N° 2010.09.22

## Protection parts for batteries on ALL the Fun Cup

Figure 1: Standard battery (E 11)

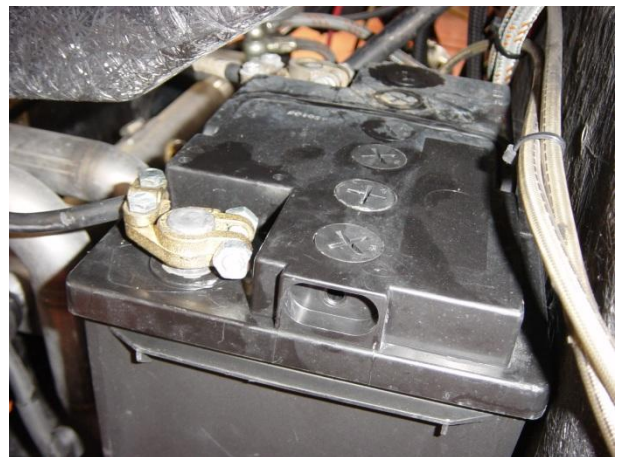
For safety reasons, we are asking you to add protection on the positive pole of your batteries to avoid short-circuit in case of crash.

Depending on the batteries you're using (figure 1, reference E 11, or figure 2, reference E 11 TD), you will respectively have to install straight protection (figure 3, reference E 028 D) or an angled one (figure 4, reference E 028 C).

Figure 5: Good fixation of the wiring and pipes in the neighborhood of the battery

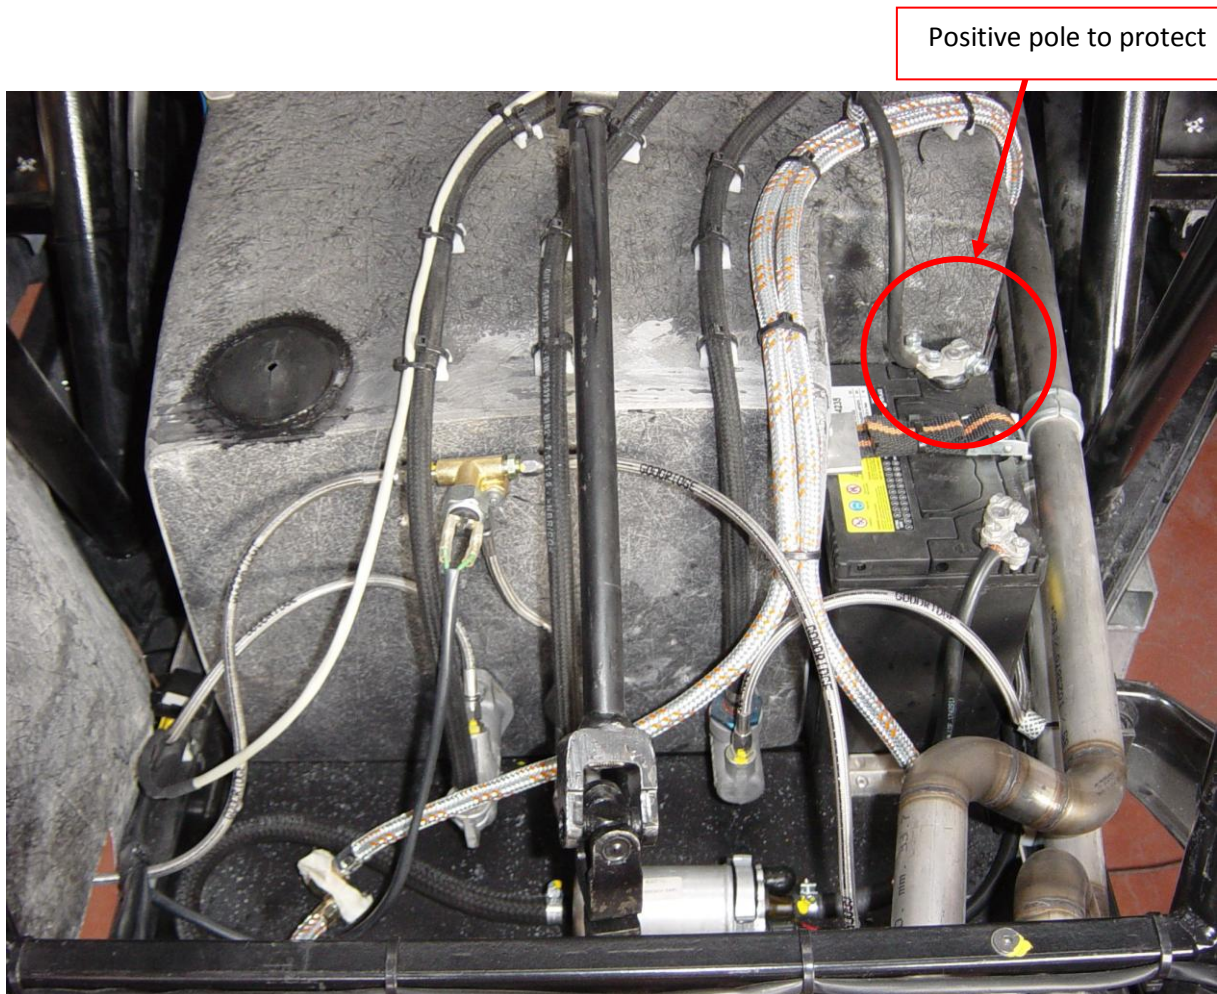
Please, also make sure that your fuel pipes are well fixed in the neighborhood of the battery and that no conducting parts can short-circuit the poles of your battery. (figure 5)
